Access Compliance Report

Public Rights-of-Way

(Curb Ramps)

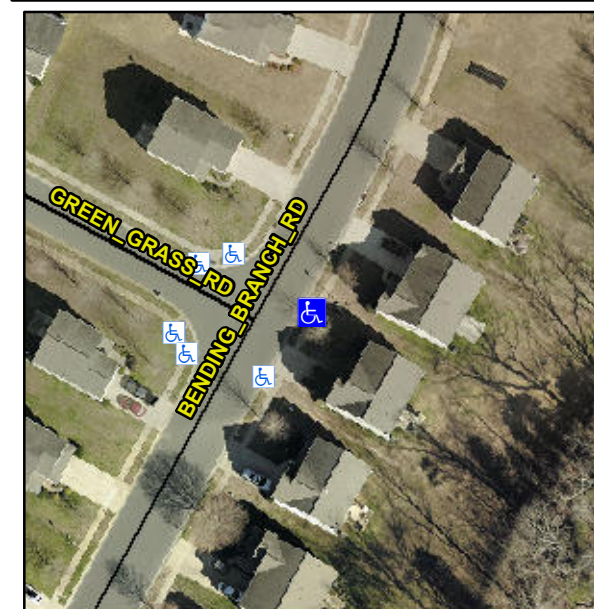
Intersection ID: 50589	Main Street: BENDING_BRANCH_RD	Cross Street: GREEN_GRASS_RD	Location: E
ADA ID: A4F49628A1B4	Ramp Type: Perp	Initial Pass/Fail: Fail	Overall Compliance: No
Severity Score: 21.25			
Codes/Mitigation Info/Possible Solution		Field Measurements/Component Compliance

Not Found, R304.5.1, R304.2.2

Possible Solutions:

Remove & Replace Entire Ramp.
